preferred project report

BALLINA GATEWAY PROJECT, BALLINA

Proposed Mixed Use Development

Revised 9 February 2007

Diagram of Building D outlining modifications

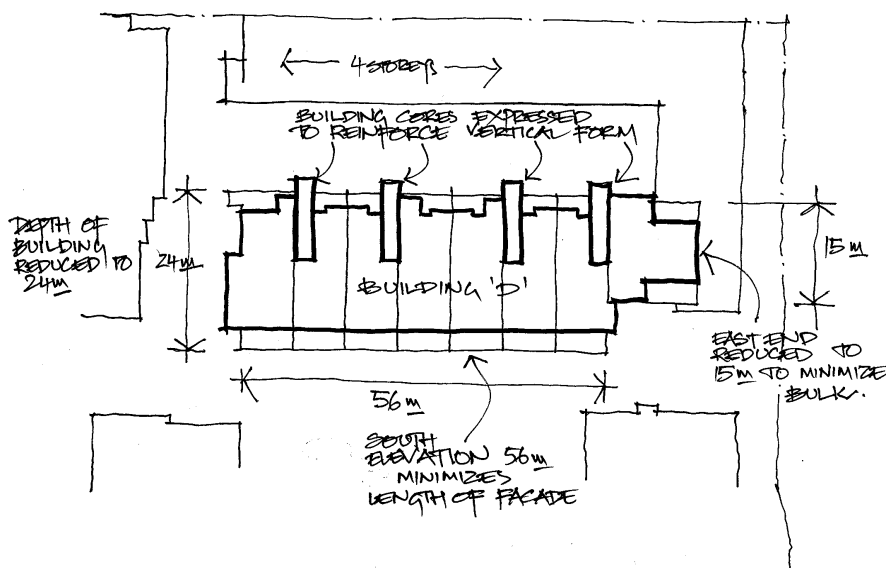
9. Building D has been reduced in depth to 24 metres overall (18 metres glass line to glass line) to comply with the requirements of SEPP 65.

This modification has been made to address the Department's concerns about the non-compliance with SEPP 65 requirements regarding building depth (as previously the building was 21 metres glass line to glass line and an overall depth of 26.5 metres including balconies). The depth of the building has been reduced to provide better amenity and a less bulky building.

Site Permeability

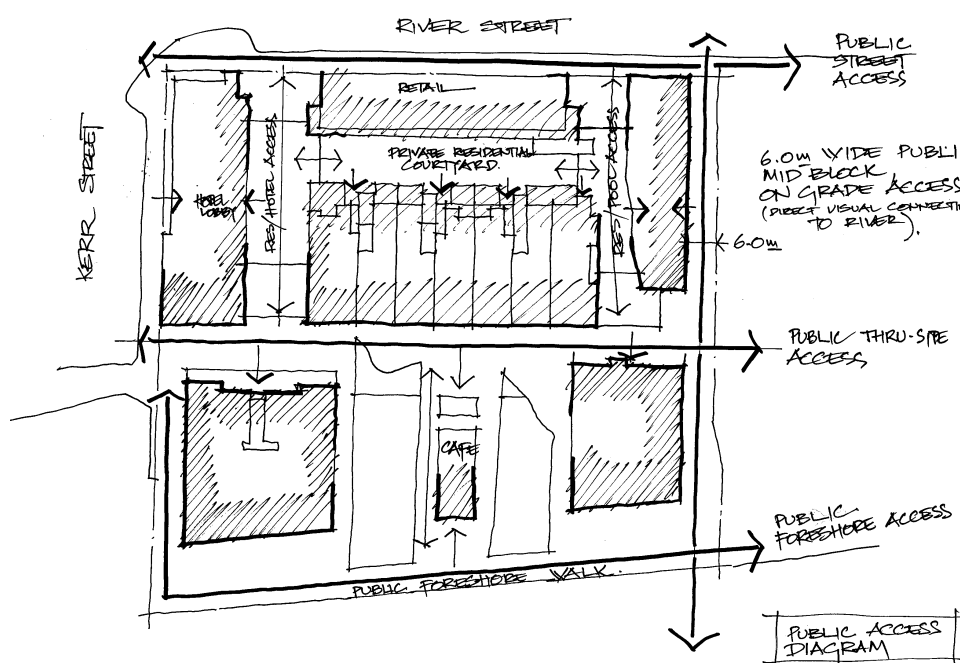
The DGRs specified that the development must provide meaningful pedestrian (residential & public) and visual linkages to the river. The proposal currently features 3 north-south through site links, none of which provide direct visual linkages to the Richmond River waterfront or slipways. Clear, direct and unimpeded connections between River Street and the Richmond River should be provided.

As previously stated in our Response to Submissions Report dated 22 December 2006, Clear, direct and unimpeded connections between River Street and the Richmond River are provided. The main public access between River Street and the river is along the east boundary. This is a 6m wide clear thoroughfare, providing uninterrupted views and access to the river. This access complies with the requirement of the *Ballina Shire Combined DCP* for mid block access between Kerr Street and Grant Street.

Other linkages are primarily for the residents and hotel patrons, for access to apartments, the pool and amenities building, the café and waterfront. These linkages are also accessible by the public (except for the secured residential courtyard between Buildings C and D).

There is a clear uninterrupted access along the foreshore.

The design also allows for east /west access in the middle of the site providing an opportunity in the future to connect directly from Kerr Street to the Memorial Park which also creates benefits for the residents from Camoola Avenue to access the park.
